DIXIE-NARCO, INC.
 SERVICE BULLETIN #129

MODELS: DN246-6, DN438-6 and DN372-6

SUBJECT: Field Sealing Kit - - - Main Door

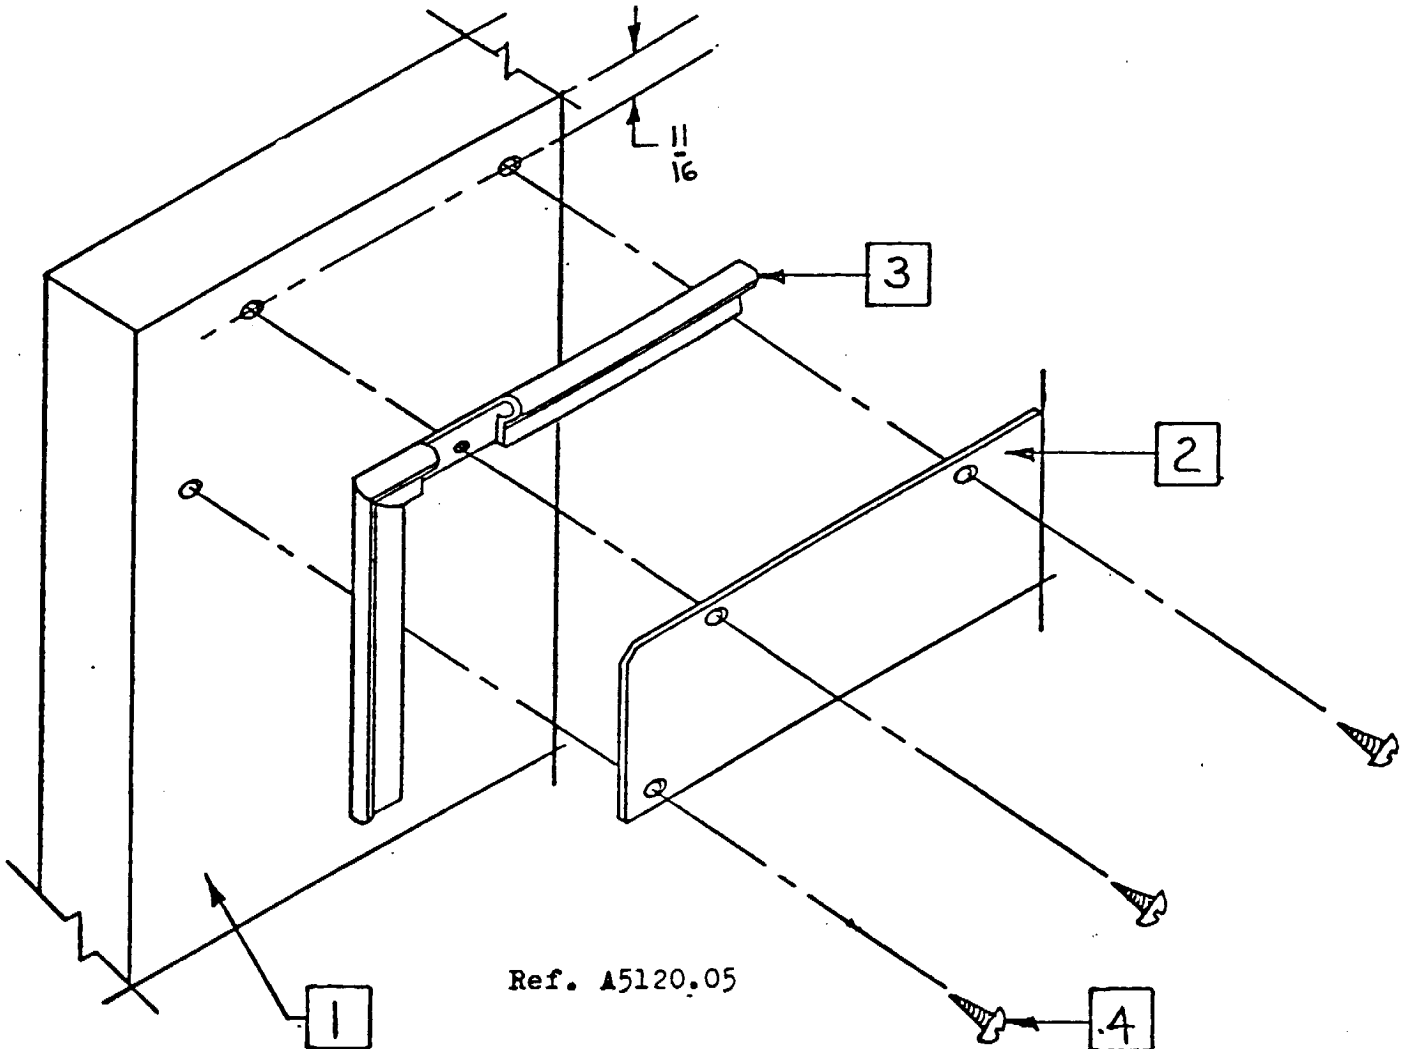
REASON: To prevent water from entering the door via the Gasket Area.

(1)	Inner Door		
Kit Consists of	(2)	Gasket Retainer	B164,010,070.03	(1 required)
	(3)	Gasket-Field Kit	B164,010,080.03	(1 required)
	(4)	Sheet Metal Screw	900,300,280.01	(7 required)

- A. Using (2) as template and dimensions shown; drill 1/8 dia holes in (1). Seven (7) places.
- B. Place (3) over (2) and attach to (1) with (4).
- C. After installation, gasket should be flush with top of door and centered from side to side of door.
